APPLICATION NO.	FILING DATE	FIRST NAMED INVENTOR	ATTORNEY DOCKET NO.	CONFIRMATION NO.
09/680,277	10/06/2000	Je Hong Kim	2658-0242P	8486

Office Action Summary

DETAILED ACTION

FIG. 4

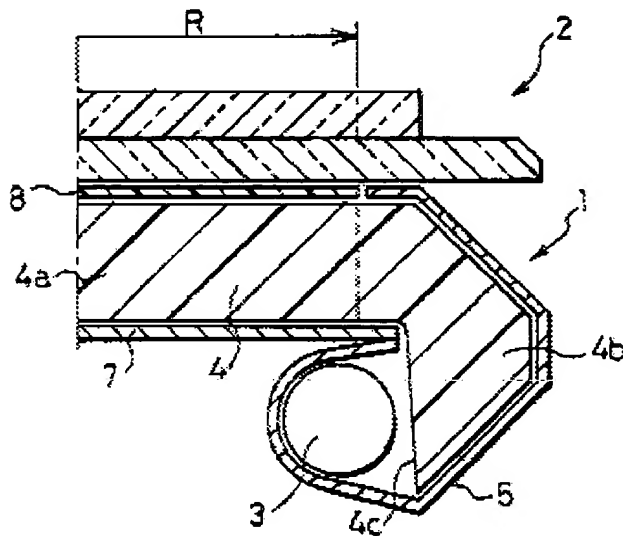
Oyama teaches in Figure 4 a light unit comprising a light-guide plate, 4a, and a reflector, 5, having a sectional view of spiral shape that efficiently guides the light

Oyama teaches in Figure 4 a light-guide plate, 4a, installed at height different from the light, 3, input to reduce the outside dimensions of the entire apparatus with respect to the area of the display space (col. 2, lines 53-60) having a sectional view of spiral shape, resulting in light passed through the light input device to be incident into the light-guide plate without being incident directly to the light-guide plate. Note this motivation (to reduce the outside dimensions of the entire apparatus) is applicable regardless of element 4b.

FIG.14(b)

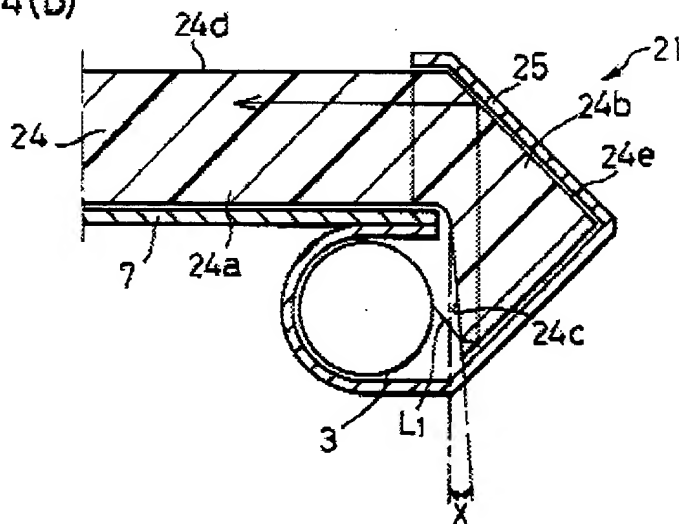
As to claim 5, Oyama teaches in Figure 14(b) a back light unit wherein the reflective plate, 25, is curved to obtain a desired vertical incident angle of the light beam progressing to the light-guide plate to reduce bright lines in the display near the light source (col. 13, lines 33-52, especially lines 42-48).

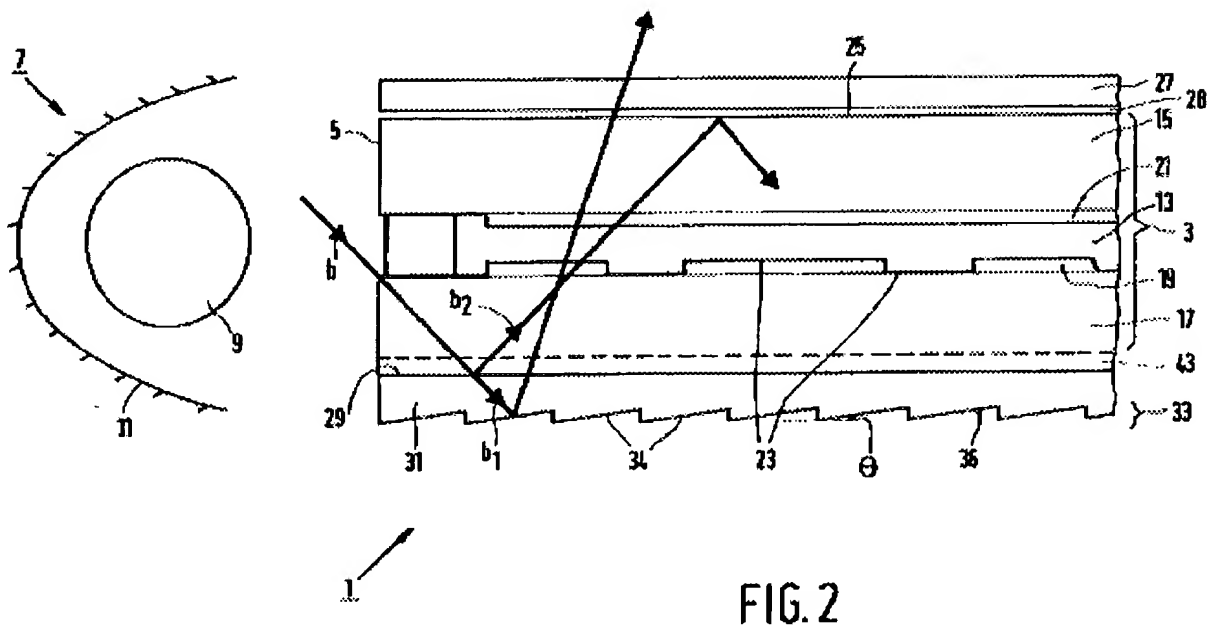
As to claim 7, Oyama teaches in Figure 14(a) a back light unit wherein the lamp housing includes at least one reflective plate for cutting off the light beam progressing directly from the lamp into the light-guide plate, the at least one reflective plate being a protrusion of the inner surface of the lamp housing.

FIG. 7

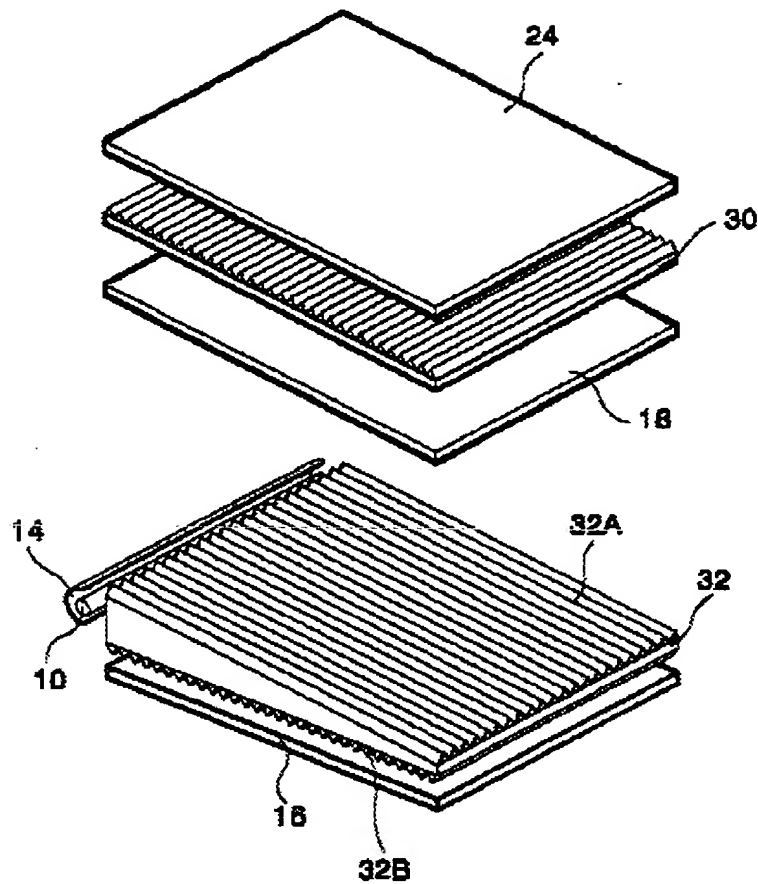
Kim teaches in Figure 7 the use of a light unit wherein the light-guide plate includes a plurality of prism patterns arranged on another surface thereof in intersection with the unit patterns.

FIG. 1

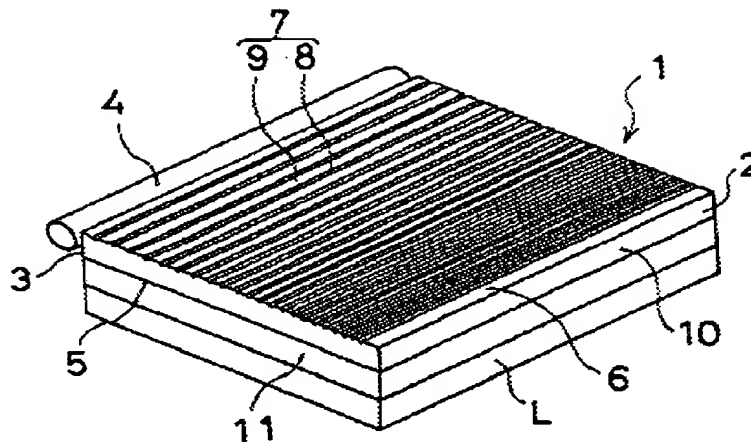
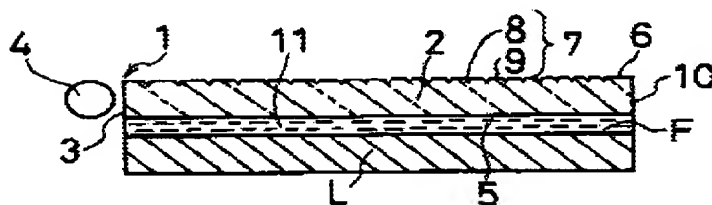
Egawa teaches in Figures 1 and 2 a light guide plate dispose on the front side of a liquid crystal panel to provide illumination without degrading contrast and without generating a moiré pattern (col. 4, lines 11-17).

Egawa teaches in Figures 1 and 2 a light guide plate wherein a distance between the unit patterns that gets gradually shorter as said unit patterns get farther away from the incident side of the light-guide plate so that the brightness becomes nearly uniform at any position in the transparent substrate (light guide) without being influenced by the distances from the light source lamp (col. 12, lines 34-50).
